New model with improved Die stopper for Pre-roller  
 New models to be produced starting from December 2011 orders.

### New Model

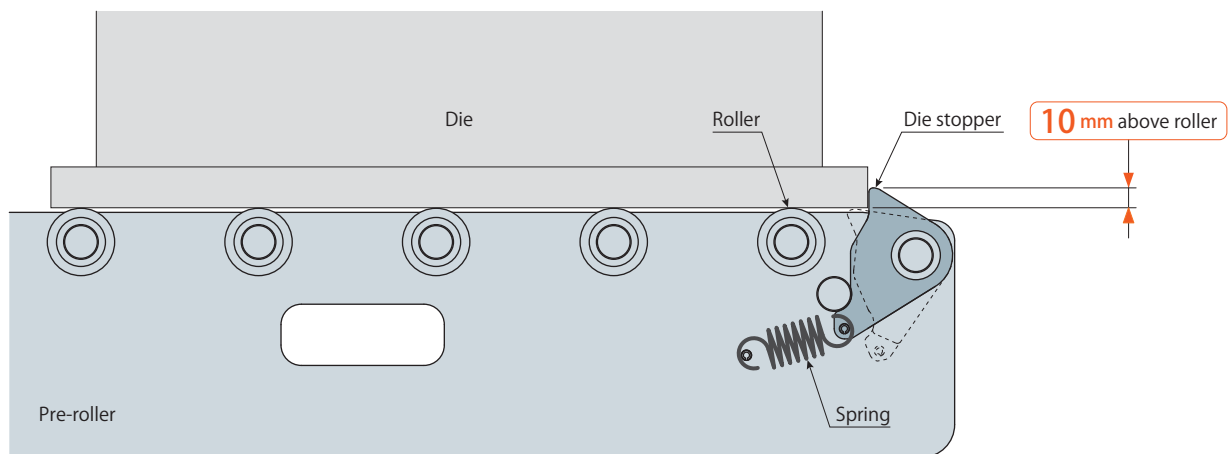
- **Height of Die stopper Increased**

To improve the safety of die exchange, the die stopper height has been changed from 5mm to 10mm.

- **Elimination of Die Stopper Lever**

With the old model, the Die Stopper could be lowered by using the lever. This lever was eliminated with our new model so that the stopper is not able to remain in the lowered position. Like the old model, when the die is lowered onto the Stopper, the Stopper will lower and prevents damage to the underside of the die.

### Old Model

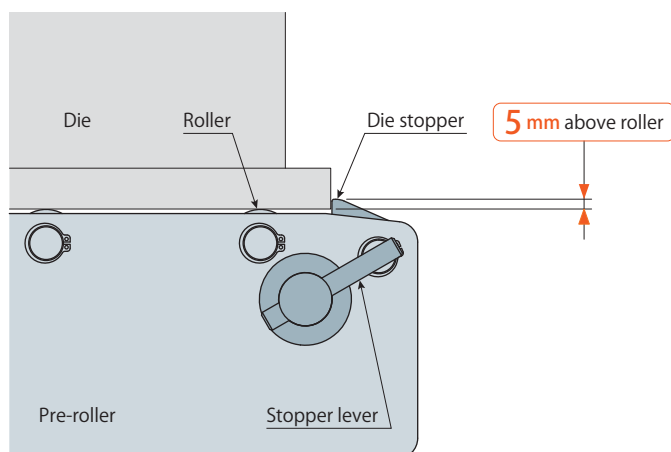
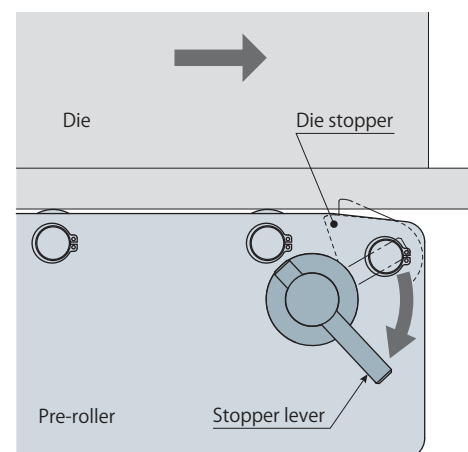
The stopper lever is commonly used to transfer the die onto delivery trucks (or similar), but has been eliminated for safety reasons with this modification.
